| W | ATFR | LICFNCF | INSPECTIO | N FORM |

| Agnico Eagle Mines Limited. | | | Eric HALEY | Eric HALEY | | |
|--|---------------------------------|--------|------------------------------------|-----------------------------------|-----------------------|--|
| 2AM-MEA1530, March 27 th , 2030 | | | Interim Environm | Interim Environmental Coordinator | | |
| 66A/8-71-2 | | | Meadowbank Pro | Meadowbank Project | | |
| October 1 st , 2020 | | | RMO J.Voisey | RMO J.Voisey | | |

Bridge at km 17.

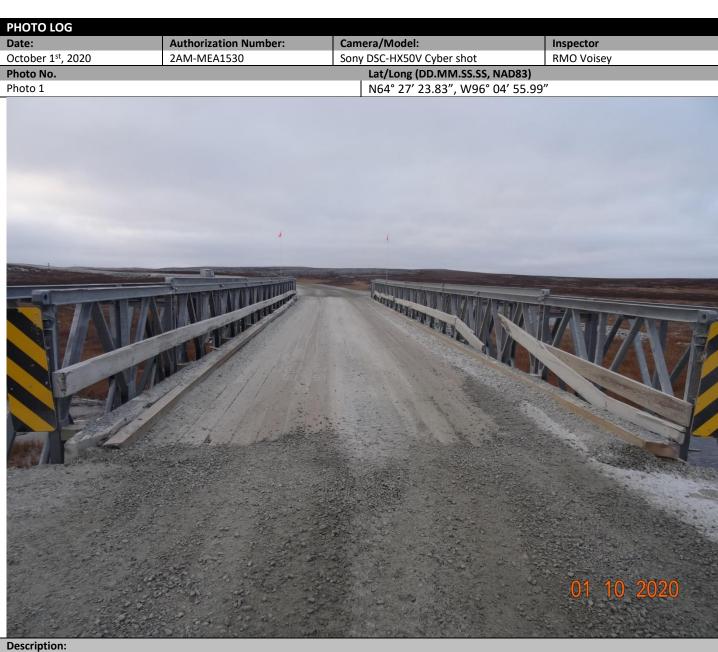
- 1. KM 9 Bridge, no concerns at this water crossing. Guard stone has been used to prevent erosion where appropriate.
- 2. KM 17 Bridge, concerns related to erosion and deposition of sediment into the water course. The abutment appears to be damaged, allowing a small amount of sediment is being washed down into the water course (photo 1-8). Erosions prevention measures should be implemented.

| Non-compliance or failures to comply related to the covenants of Water Licence no. 2AM-MEA1530: | | | | | |
|--|--|--|--|--|--|
| The Licensee will provide the Inspector with a summa | ry of the maintenance that will be completed this year | | | | |
| on all the water crossings to prevent further sediment from entering the water course. This summary is due | | | | | |
| July 1 st 2021. | | | | | |
